## Groundwater Application Review Summary Form

Application # G- 18438

GW Reviewer Phillip Marcy Date Review Completed: 5/30/2017

SUBJECT: Application G- 18438 Supersedes review of \_\_\_\_\_  
Date of Review(s)

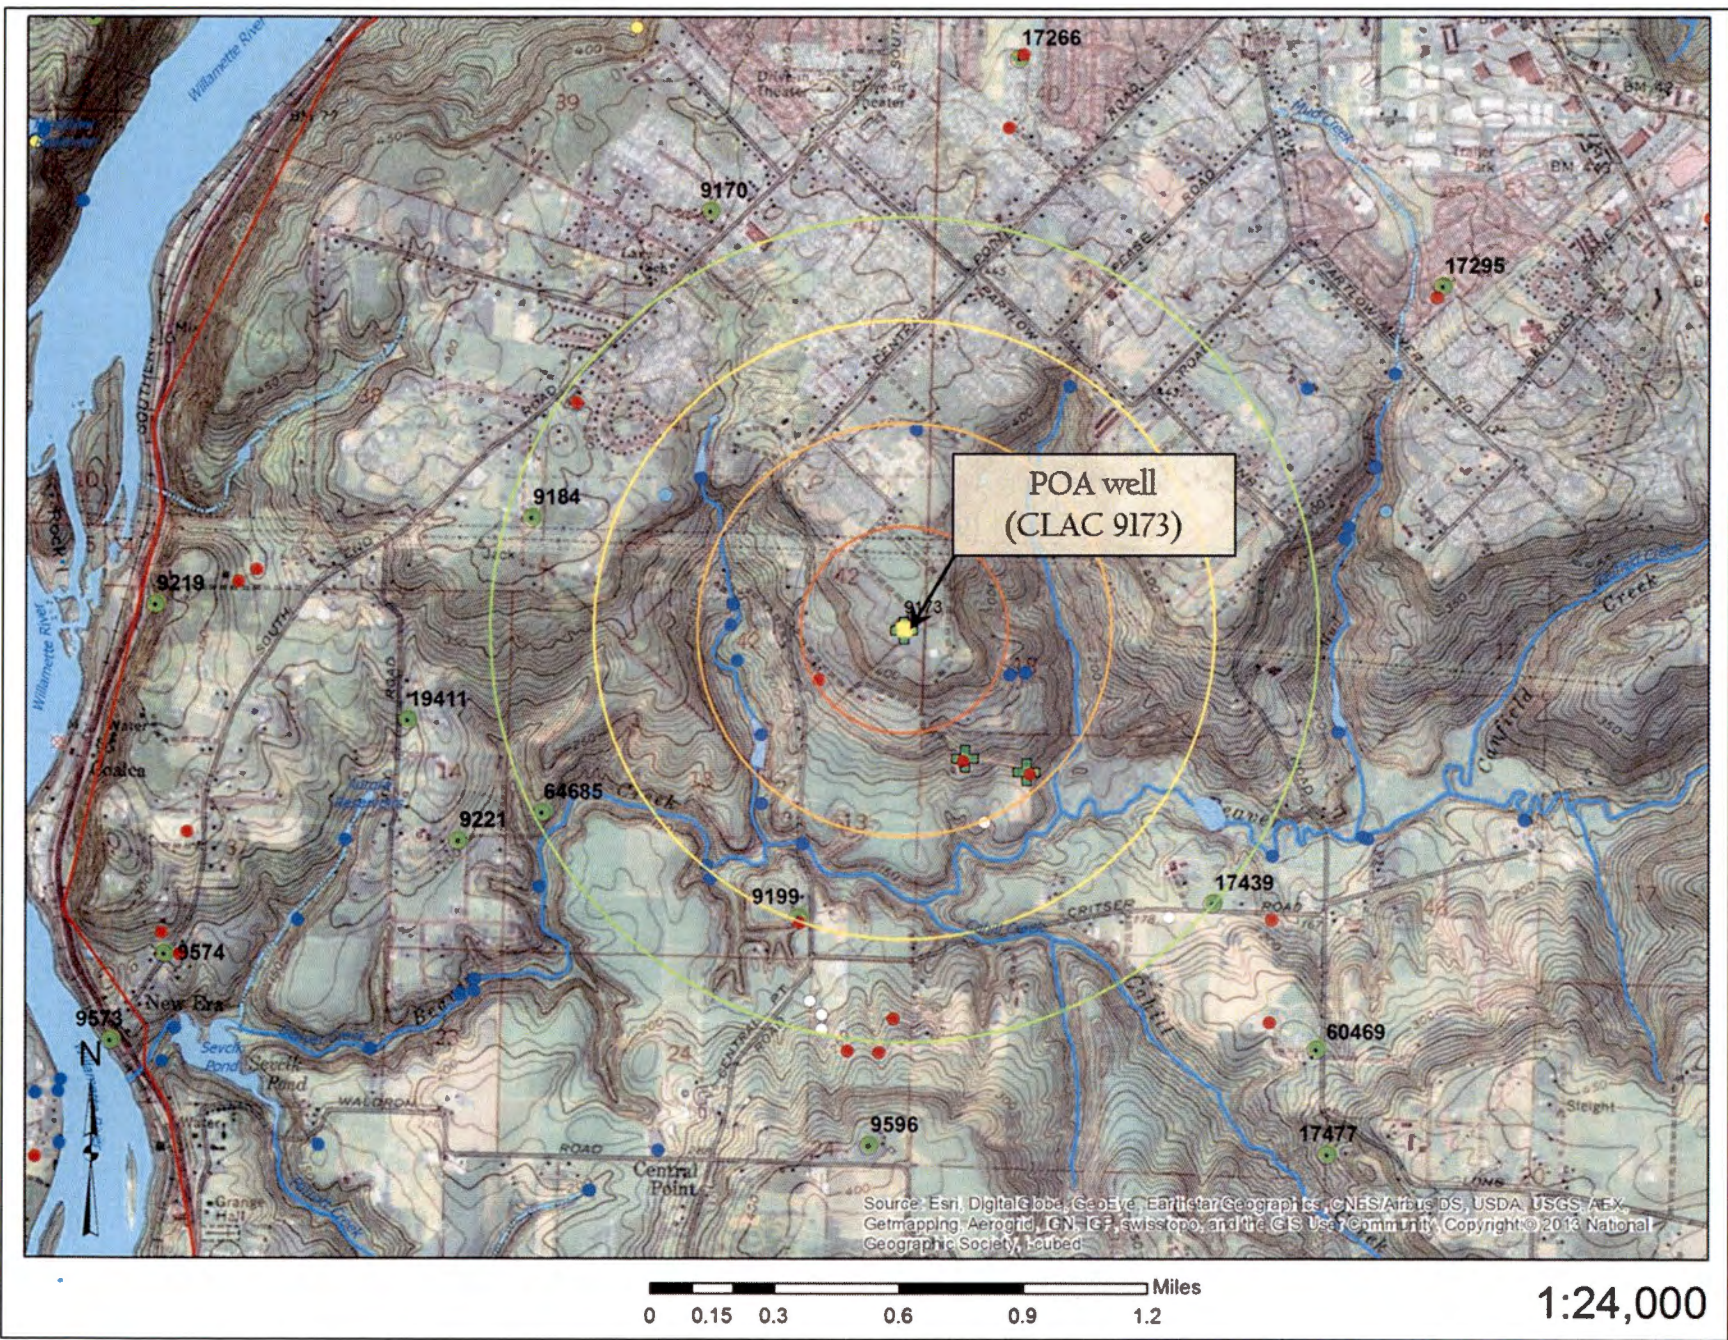
D2. **THE WELL does not appear to meet current well construction standards based upon:**

D3. **THE WELL construction deficiency or other comment is described as follows:** \_\_\_\_\_

D4.  Route to the Well Construction and Compliance Section for a review of existing well construction.
